CORRIGENDUM - 01 TO NIT NO-181208

Subject: Corrigendum-01 to Tender enquiry for Pre-Bid Tie up with the GIS OEM for Supply & Services of 400kV, 220kV & 66kV GIS and Its associated equipment for DTL's 400/220/66kV GIS Tikrikhurd Tender/ project.

Project : DTL's 400/220/66kV GIS Tikrikhurd
Equipment / Item : Supply & Services of 400kV, 220kV & 66kV GIS and Its associated equipment
Enquiry No/Date : 61Q2700123 Dated 02-09-2026
BHEL NIT NO : 181208
Original Tender due date : 09-09-2026

CORRIGENDUM-II

TENTATIVE SINGLE LINE DIAGRAM (SLD) OF 400/220/66 kV GIS S/STN. AT TIKRI KHURD

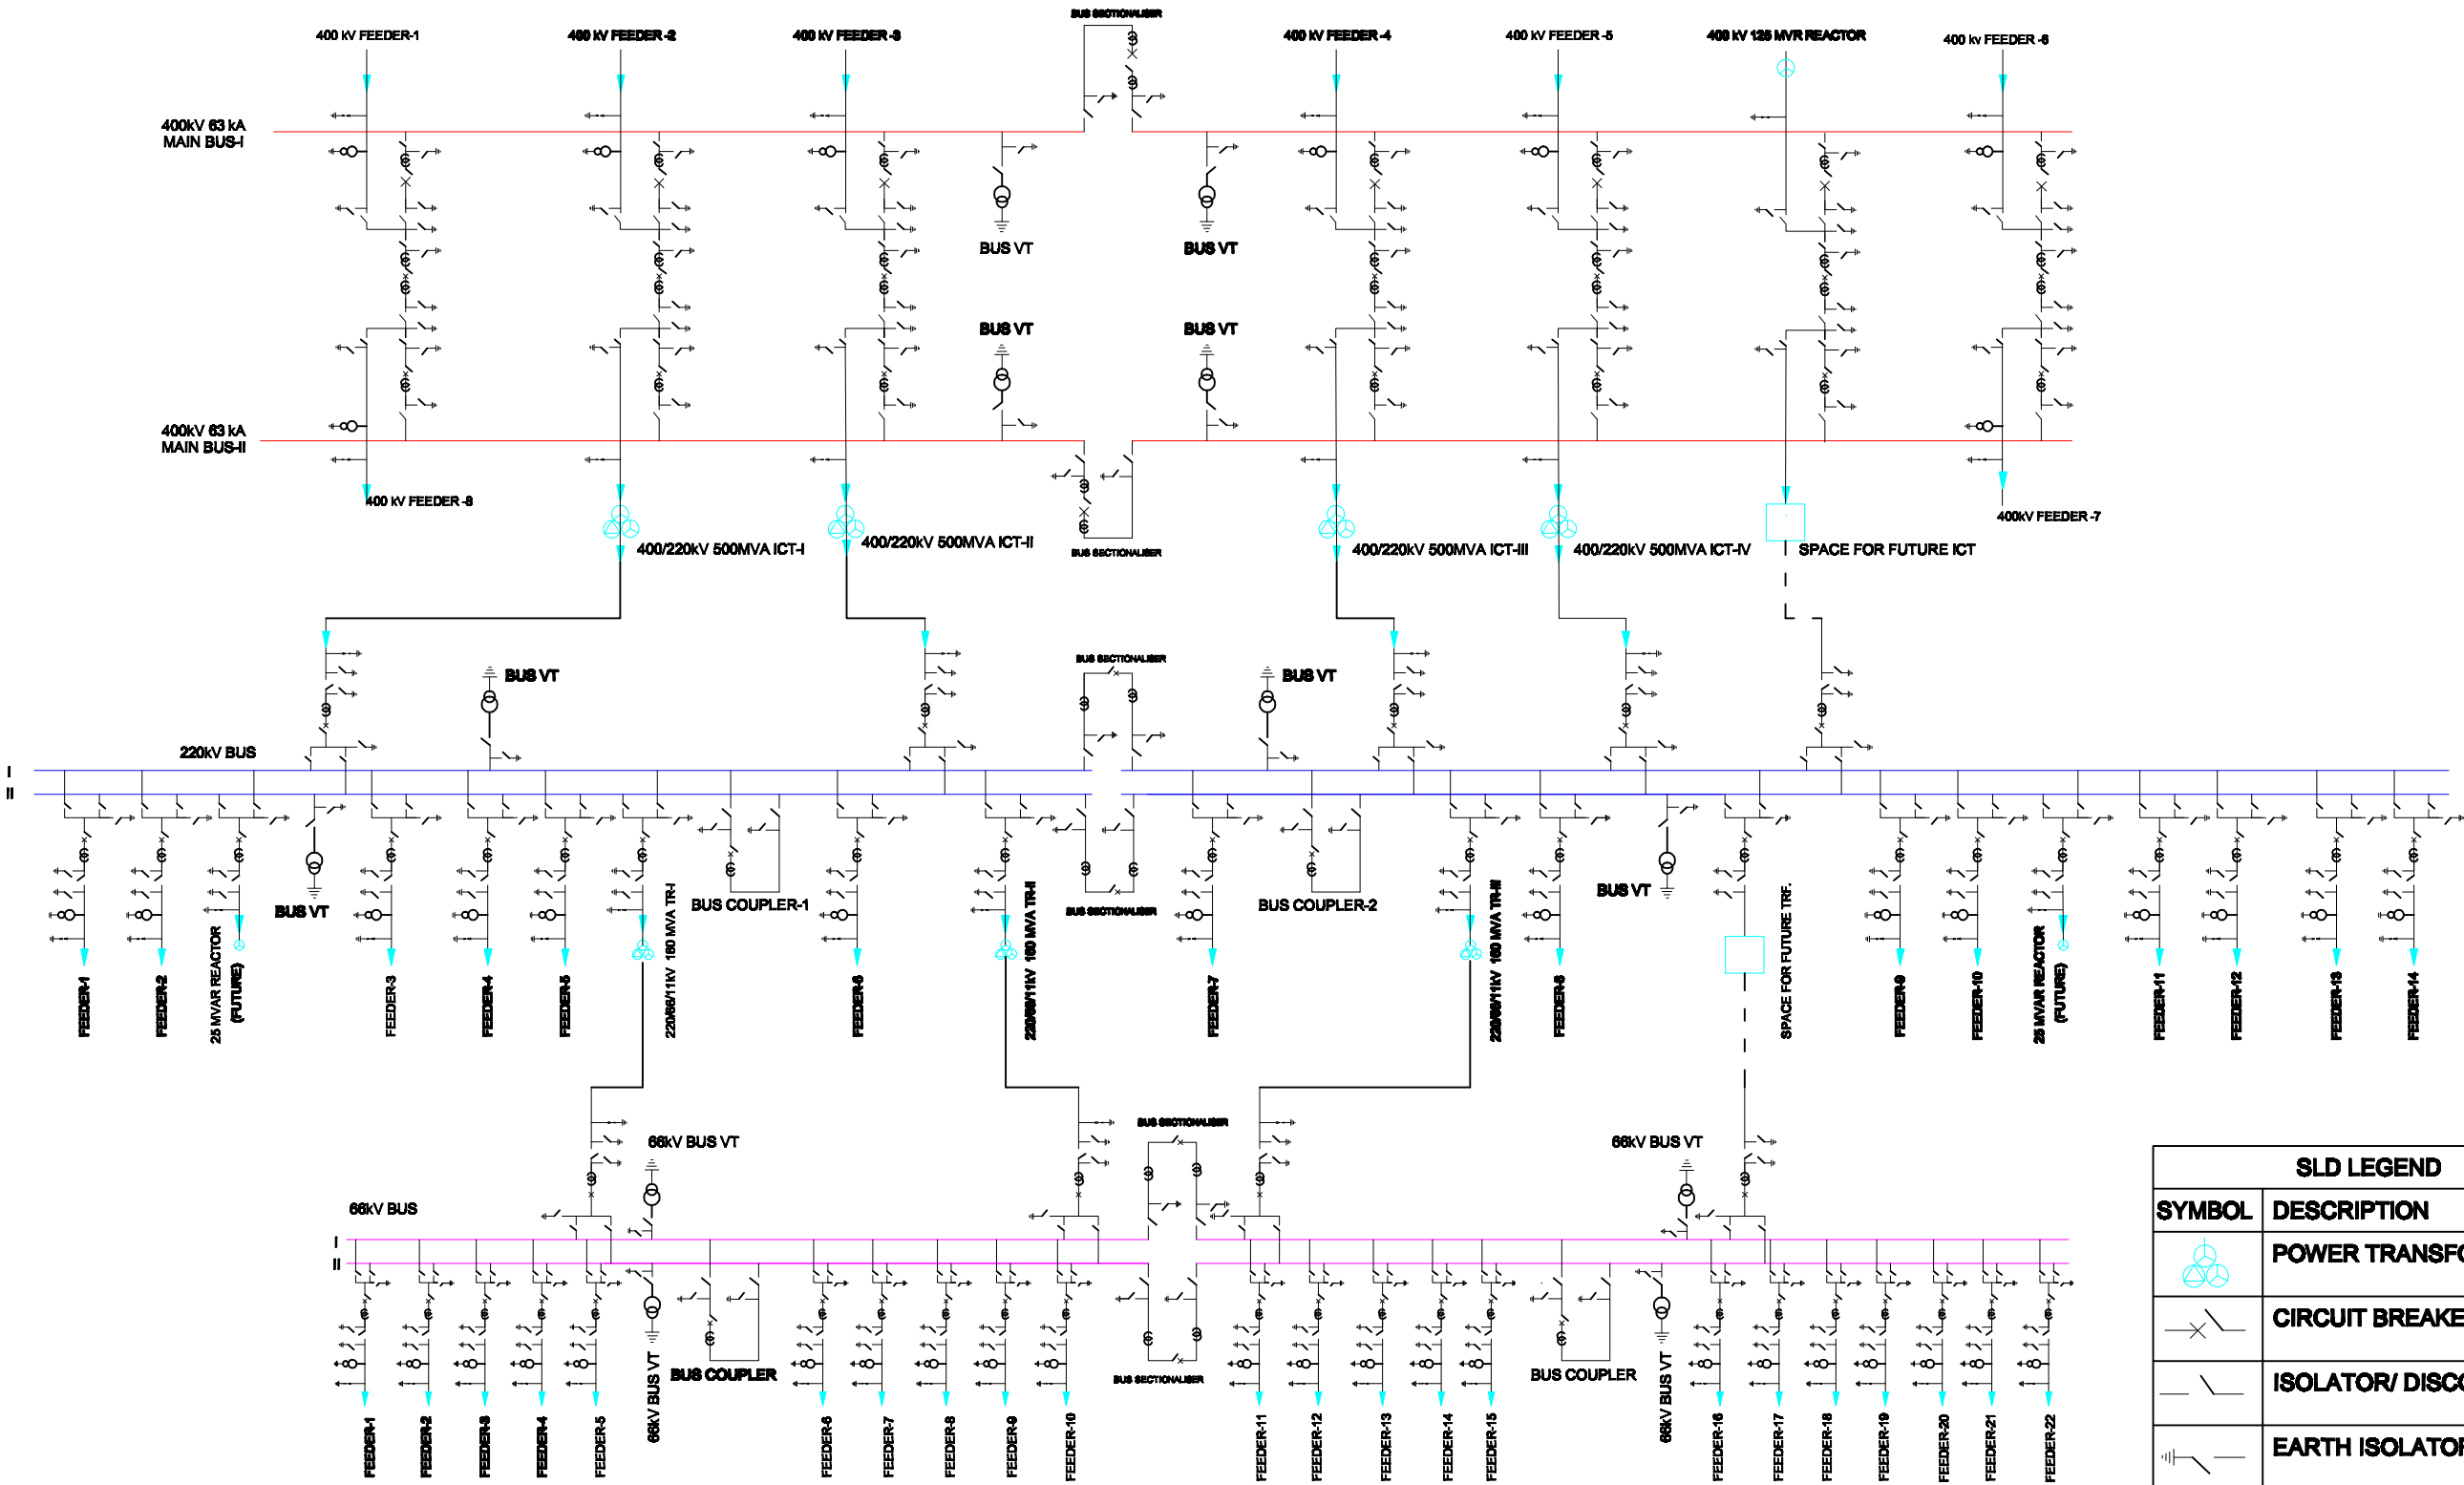
S. No.	Reference NIT Clause/ Description	NIT / Tender Clause	Bidders Query	DTL's Reply
			the same.	
36.	Page no. 265/1218 Annexure -IIA Bus VT for 220, 66kV	As per customer's SLD	We would like to inform you that, as per customer's SLD Bus VT is shown as DS/ES, we are currently considering Bus VT with DS/ES/HES. Kindly confirm and accept the same.	As per NIT

82.	General	SLD and Layout	The copies of the Substation Layout and Single Line Diagram (SLD) provided with the tender are not sufficiently legible for detailed engineering review. We request the DTL to kindly provide clear and readable copies of the Substation Layout and SLD for proper assessment of the project requirements.	Enclosed

TENTATIVE LAYOUT OF 400/220/66 kV GIS SUB STATION AT TIKRI KHURD

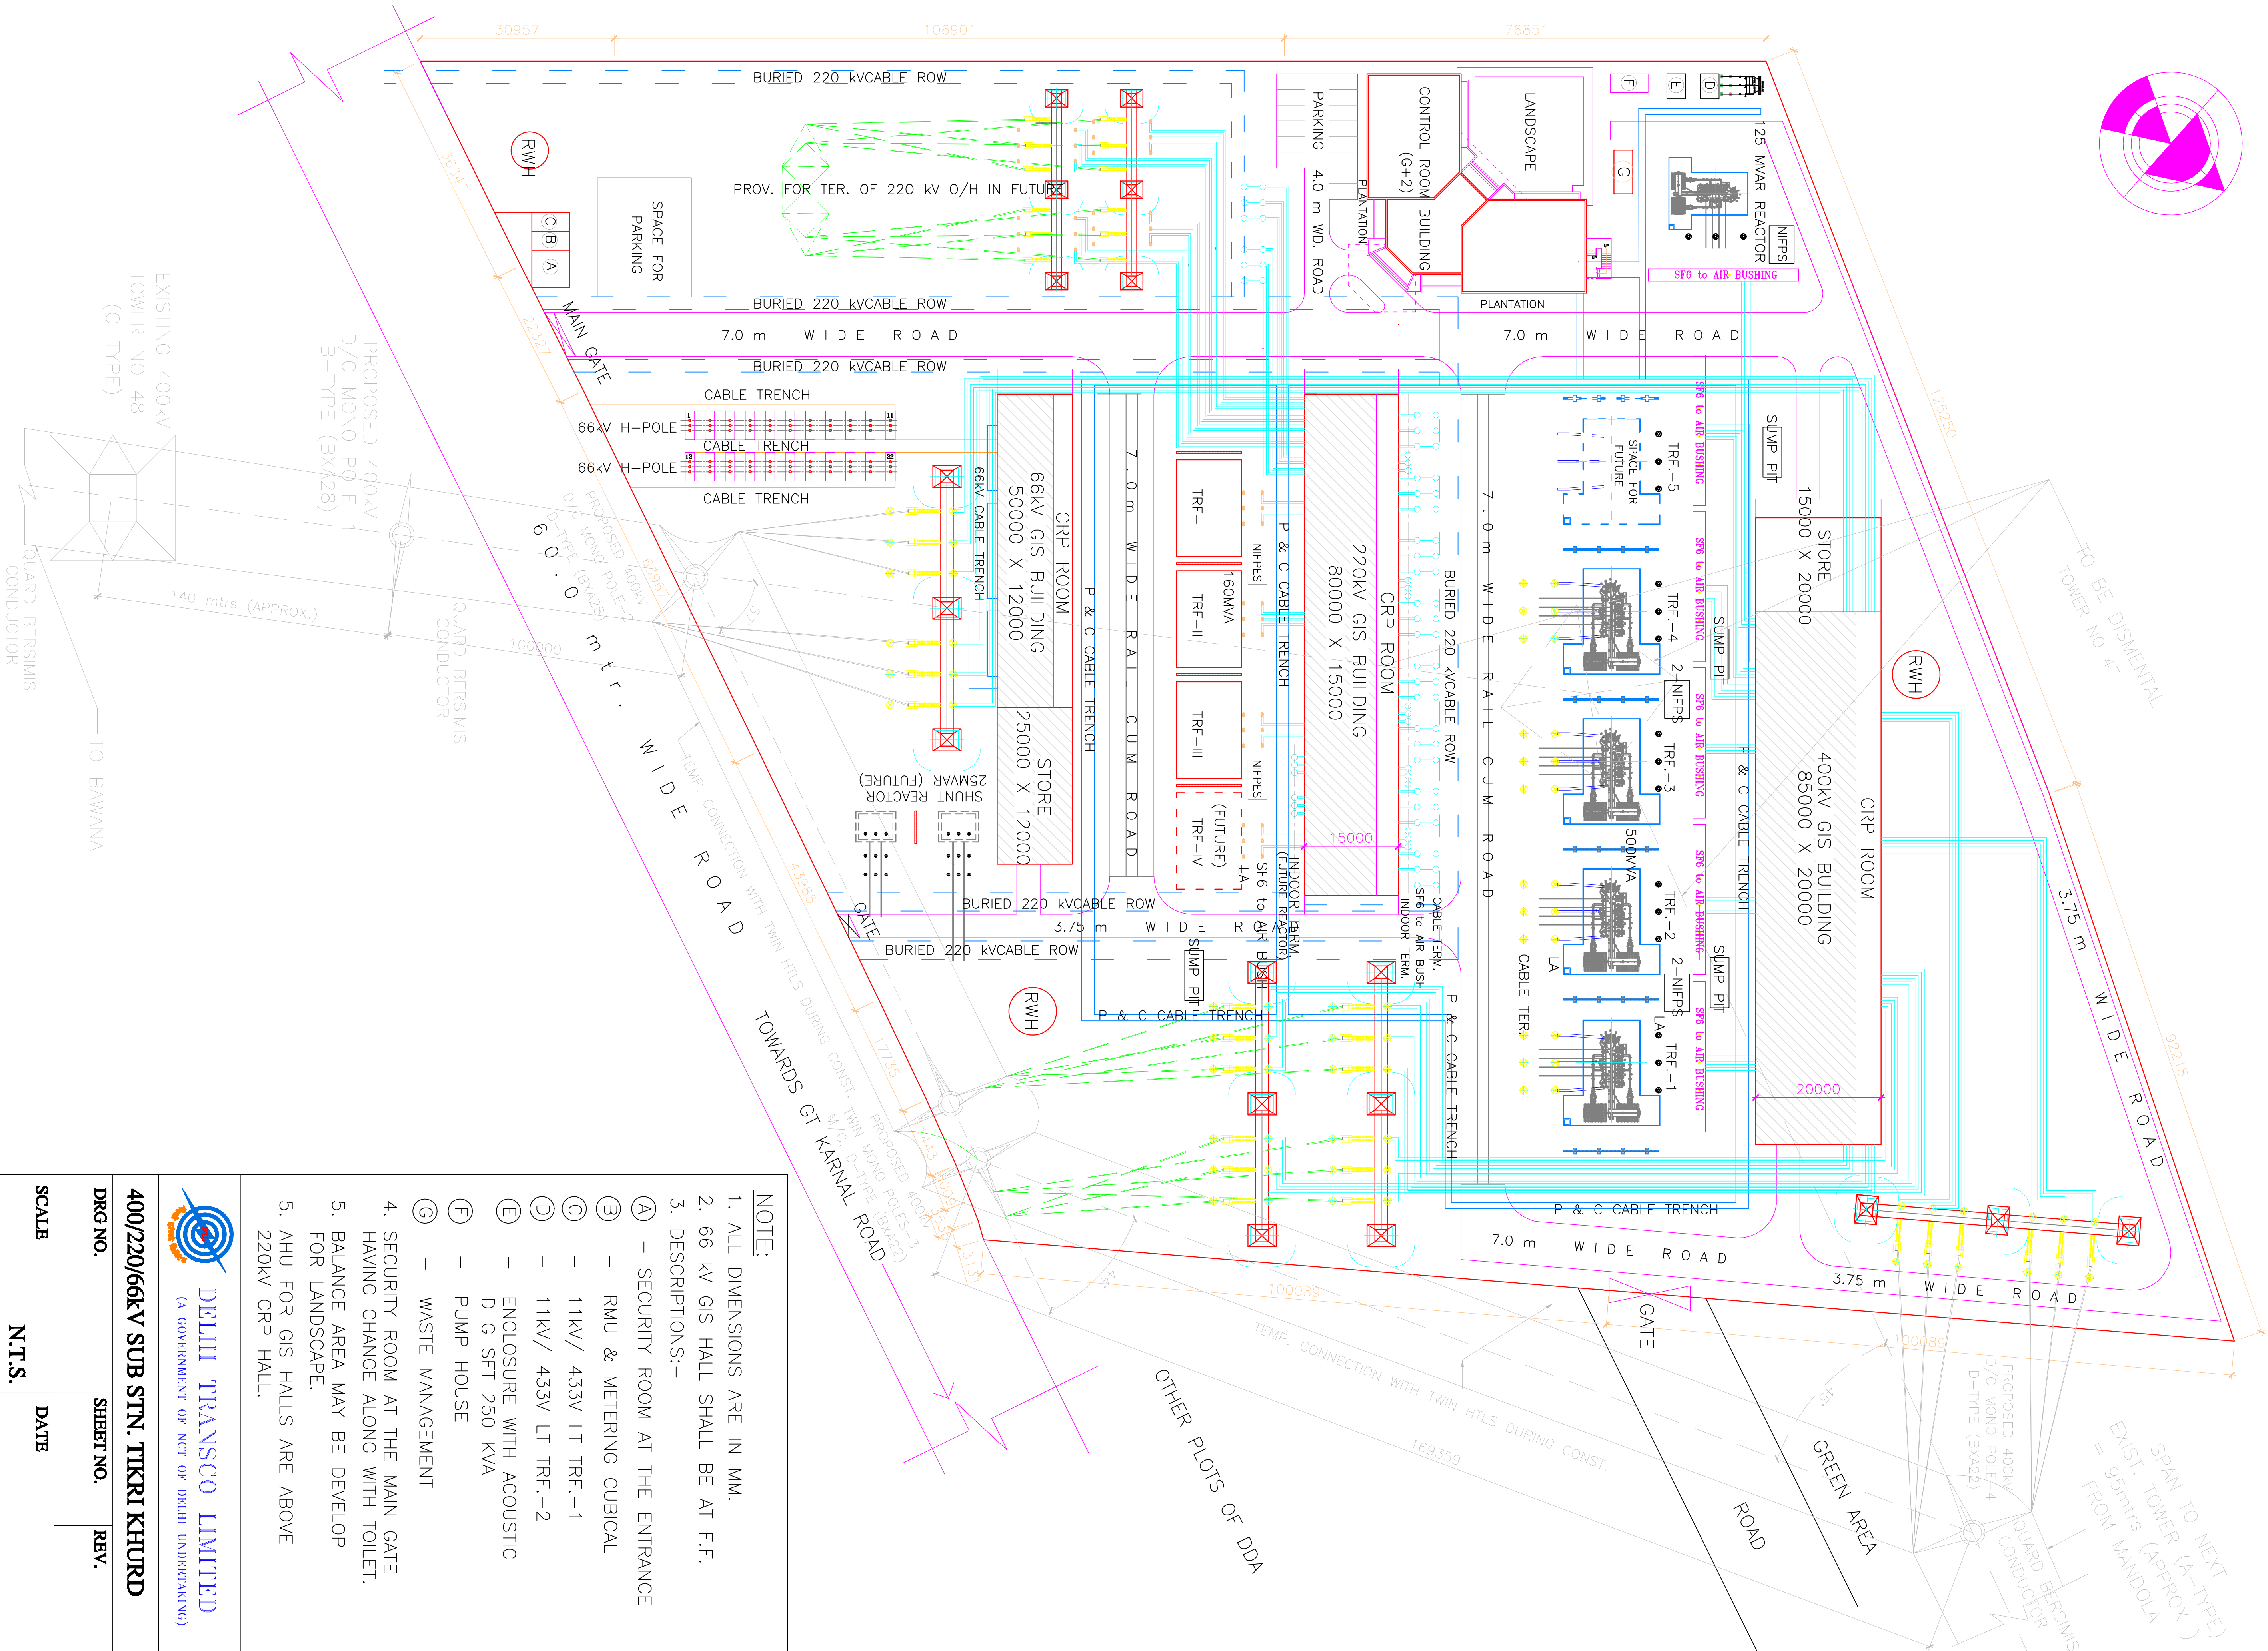
233.	Layout	66kV GIS building	As per the layout 66kV GIS bldg is of 50MX12M i.e. 600 sqm but as per the civil scope of works 66kV GIS building is of 500 sqm. Kindly clarify which building dimensions need to be considered.	The dimension mentioned in the tentative layout / BPS is tentative. However, complete Design and Engineering is in the scope of bidder which is to be finalized during Detailed Engineering without compromising the clearances as per prevailing guidelines/regulations.
